A	ISSUED FOR DEVELOPMENT APPLICATION S96	01/2017
REV.	DESCRIPTION	DATE

0 2.5 5 10m
1:250 @ A1
JANUARY 2017
For information **DA S96 2208-1[A]**

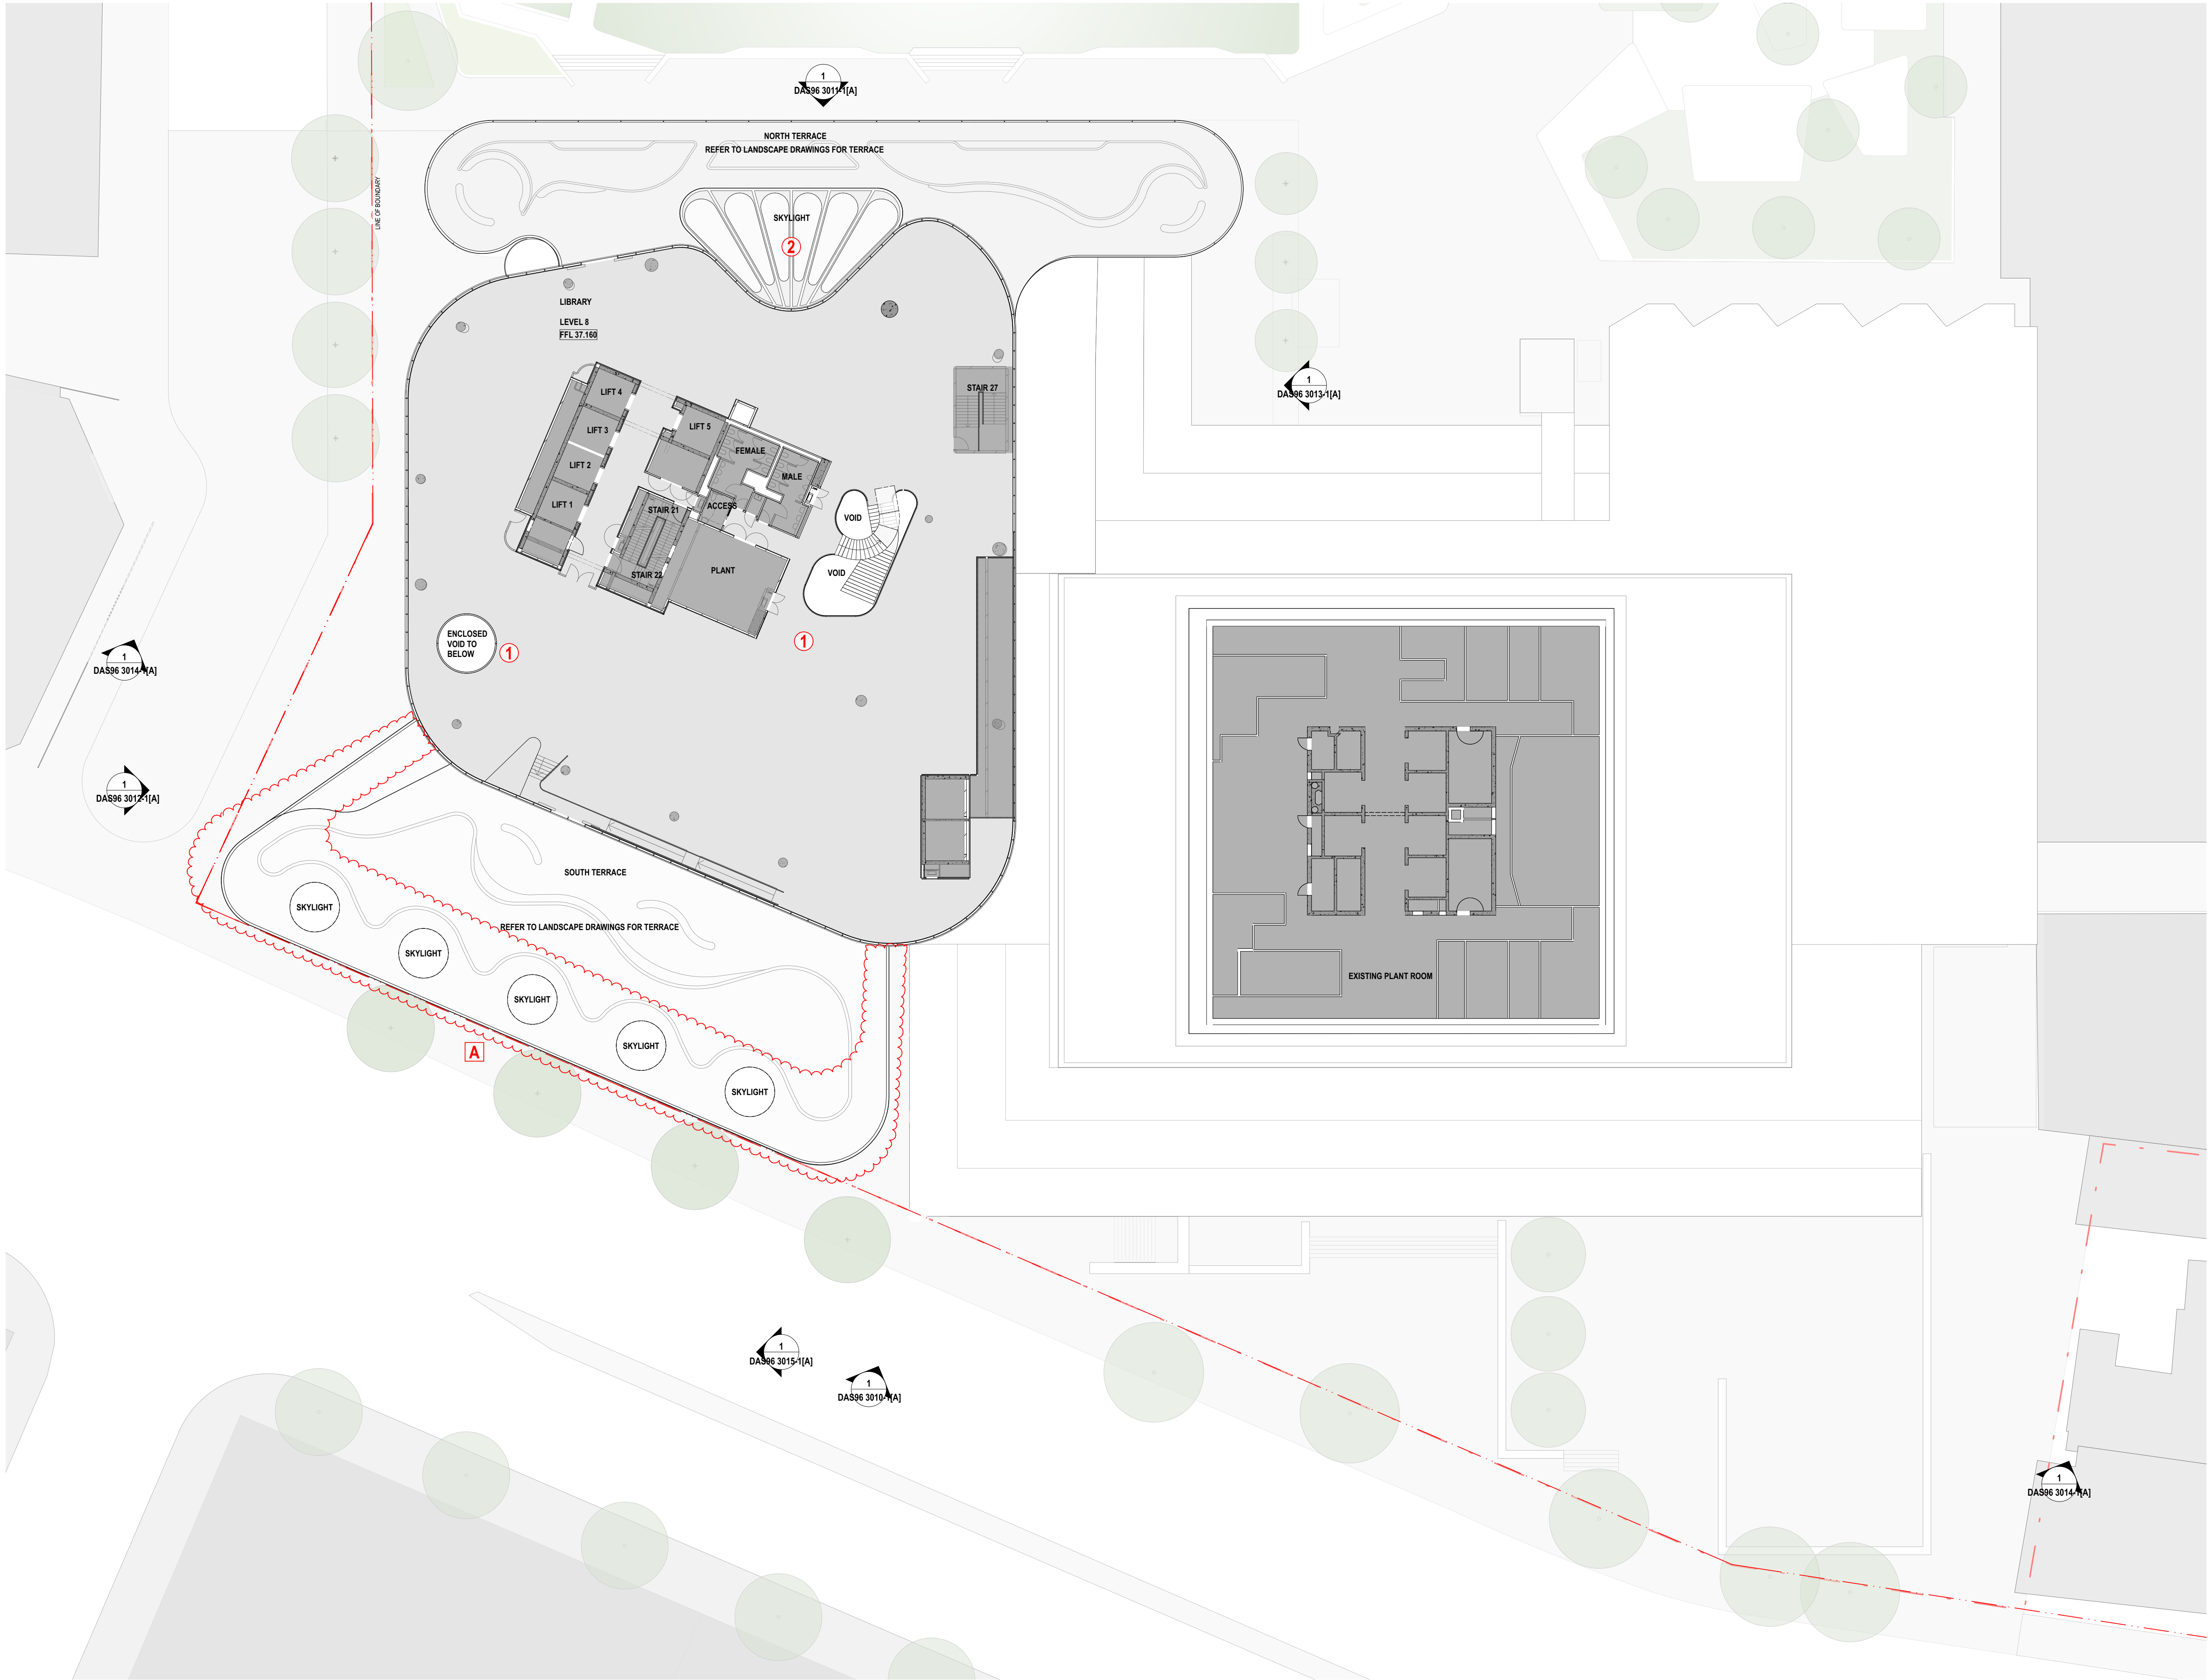
- CHANGES**
- ① RECONFIGURATION OF VERTICAL CIRCULATION
 - ② ADJUSTMENT TO LEVEL 8 FACADE TO TERRACE & SKYLIGHT EXTENT
 - A PHASE 1 ADJUSTMENT
 - POSITION OF BROADWAY FACADE
 - INCREASED NUMBER OF SKYLIGHTS
 - ADJUSTED LANDSCAPE
